RECEIPT DATE: 2/22/23 **ONSITE SEWAGE DISPOSAL SYSTEM**

I have the following revision comments that need to be addressed on the OSDS plan submittal from November 9th, 2021.

ONSITE SEWAGE DISPOSAL SYSTEM DESIGN PLAN

HAY MEADOW OVERLOOK
LOT 2
PLAT No. 21740
530 WATERSVILLE ROAD, MOUNT AIRY, MD, 21771
TAX MAP 2, GRID 15, PARCEL 18
4TH ELECTION DISTRICT
HOWARD COUNTY, MARYLAND
SCALE: 1" = 20'
JOB NO.: 3696
DATE: JUNE 2, 2022
SHEET: 1 OF 1

ONSITE SEWAGE DISPOSAL SYSTEM DESIGN PLAN

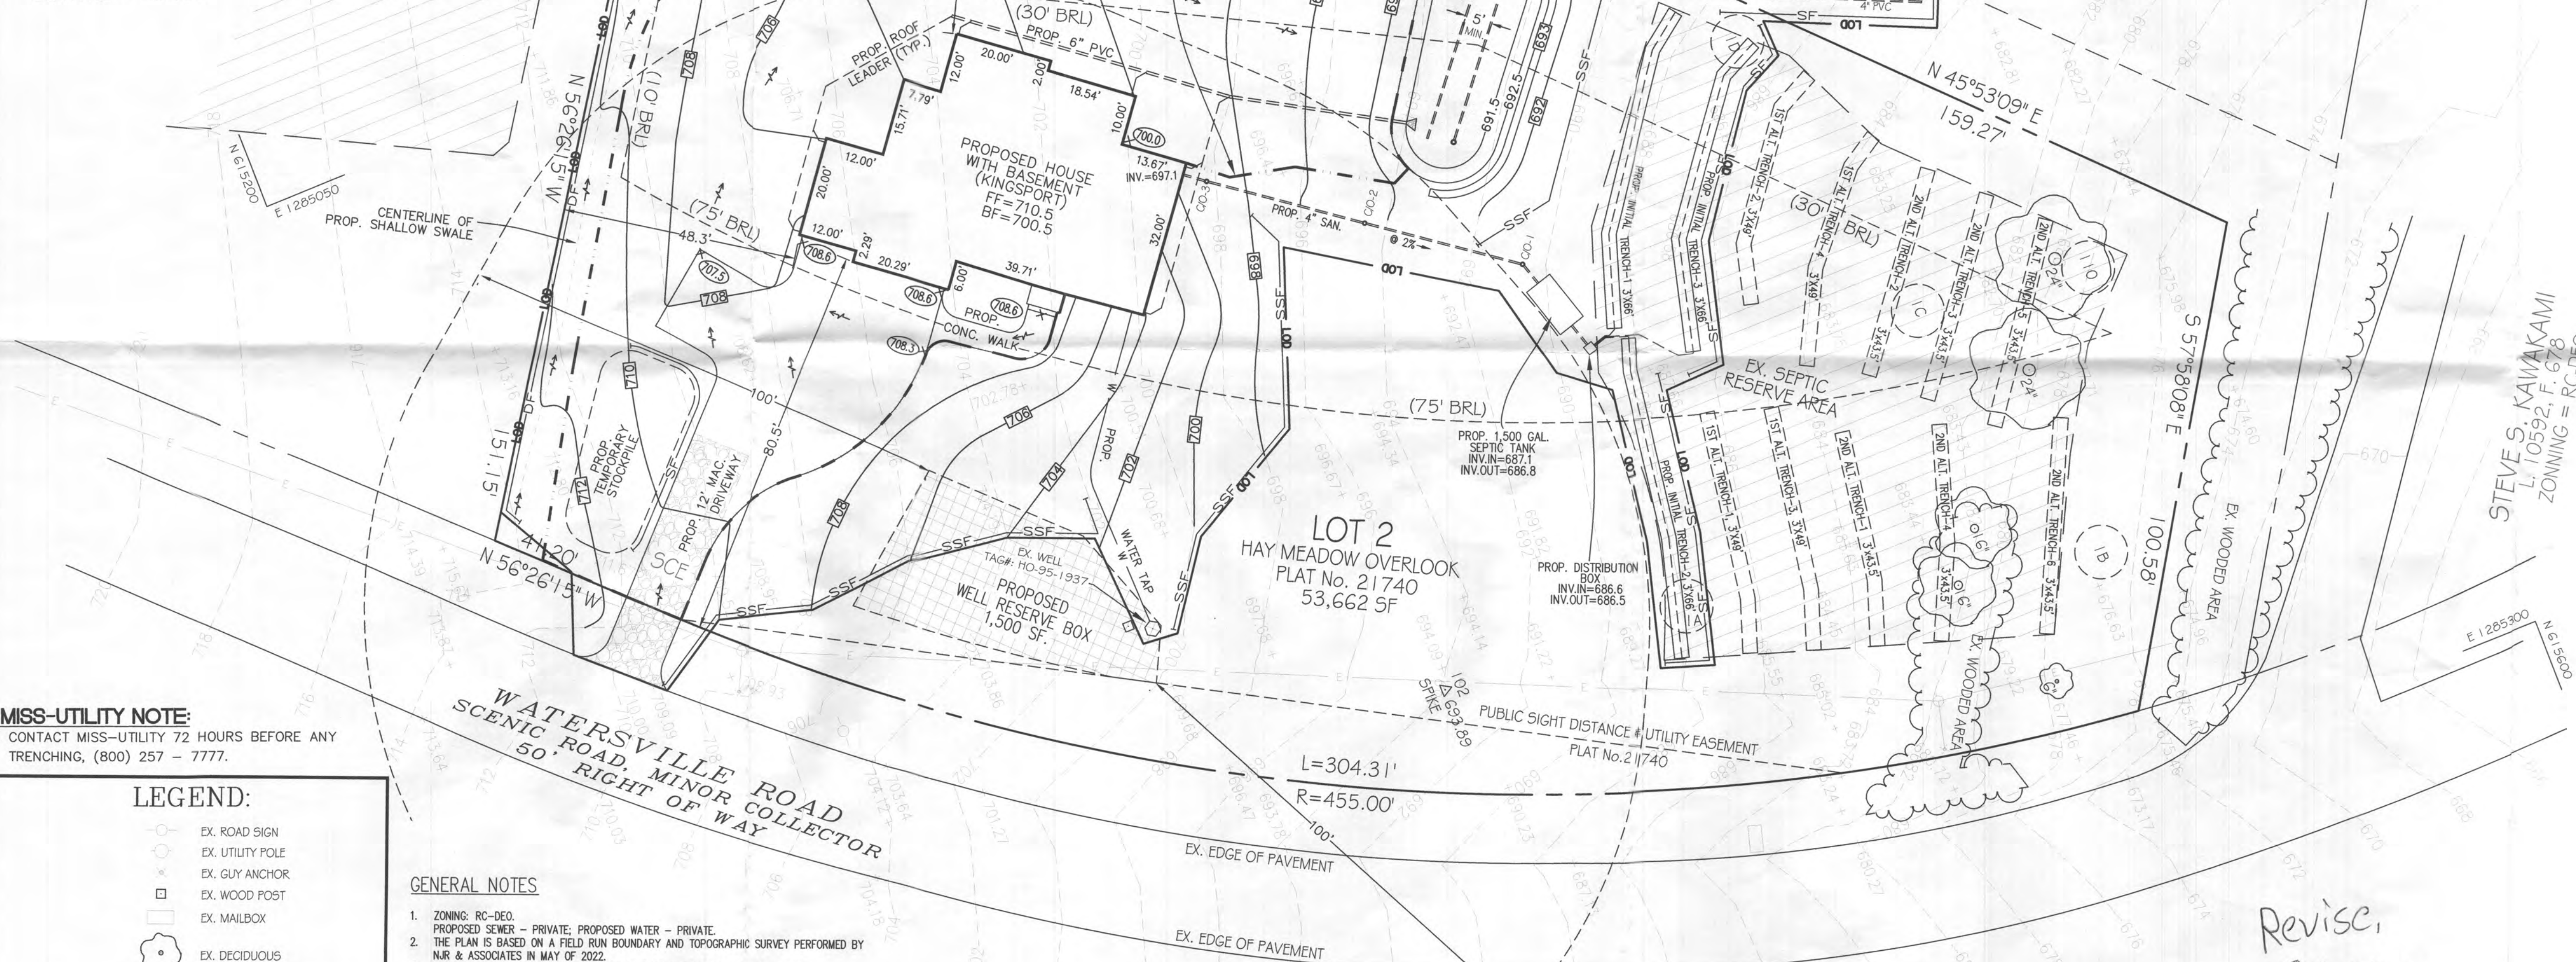
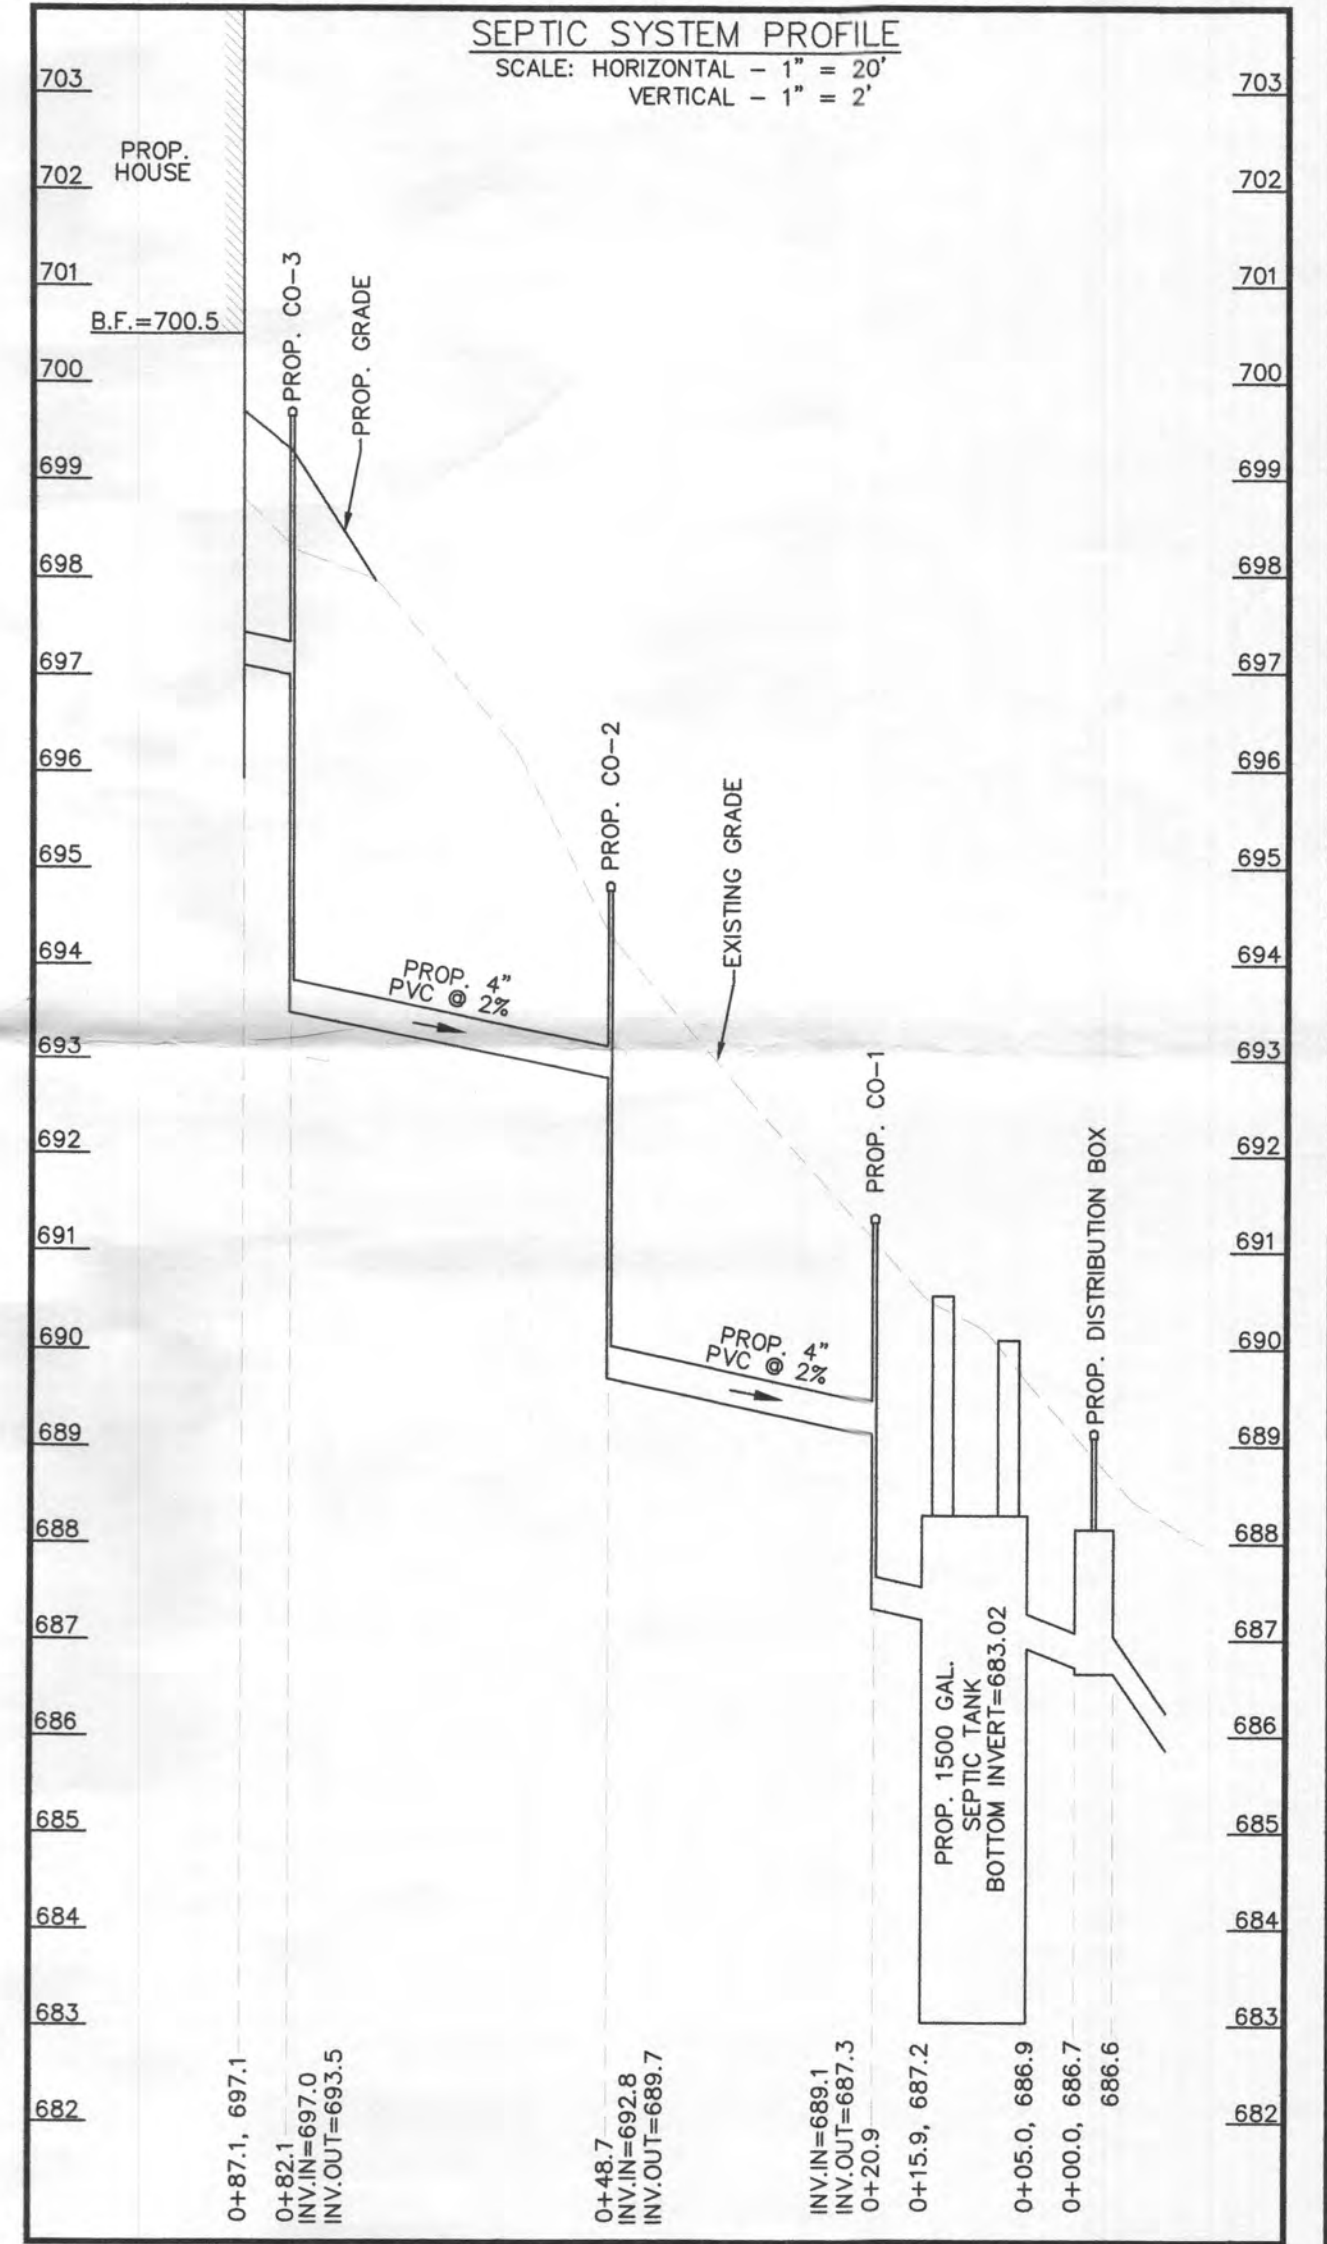
Unfortunately I cannot tell you exactly how to do your design or "draw it out" for you. I can only tell you that you have a 10,000 SF area. And I see a lot of cramming in of the septic systems, 45 degree bends without proper labeling, and a waste of usable area.

The tank could be moved higher to allow the dbx to come down even with the first set of trenches. I would make the initial system 4 lines, the 1st replacement system 5 lines, and the second replacement system 7 lines. And I would keep the lines as straight and on contour as possible.

The well arc is shown but could be properly labeled, and it's not in the legend. I would add the SF of the SDA like this for example, existing 10,005sf Septic Reserve Area, right on the site plan.

1. **The initial system's trenches need to be adjusted, it's too cramped.**
 - a. I suggest going back to a 4 line design for the initial.
2. **The spacing of all three systems seems unnecessary with large gaps of 20' or larger.**
 - a. This is unnecessarily wasting precious SDA.
3. **The trench lines should remain on contour as best as possible but bending some pipes and not bending others is not realistic.**
 - a. Ideally the lines should be as straight as possible within reason.
4. **Generally, a distributions box will have a 45 degree bend in it in order to be even in line with the first two trenches.**
 - a. A d-box higher away from the beginning drainfield lines with 3 spider stems coming out of the box is not economical nor ergodynamic.
5. **Should show the 100' well arc around the proposed well box.**
6. **Label the 10,000 sf SDA.**

As you know, due to the poor quality of the soil on this site, we need a total of 652 linear feet of trenches for the three systems and by spacing the trenches at 10' and following the contours, this was a very tight fit.

At the locations where we have up to 20' gaps, if offset the edge by 10', you will find the gaps to be barely enough. As far as the trench bending goes, I had my other plans previously rejected for not being parallel to contours.

Would it be possible if you can mark up a copy of our site plan for the way you prefer these trenches so I can follow that as a guide as I had a tough time fitting these trenches?

I am attaching the plan as it was printed for our previous submission as your comment number 5 is indicating the need for a 100' circle around a proposed well where on this site, the well is existing and a 100' circle around a proposed 1500 sf well reserve box is included. Also comment number 6 indicates the 10,000 sf SDA to be labeled. Our plan has this area labeled as "Ex. Septic Reserve Area" and the plat of subdivision has this area labeled as "Private Septic Easement, 10,003 sf", can you please clarify which one is the preferred label?
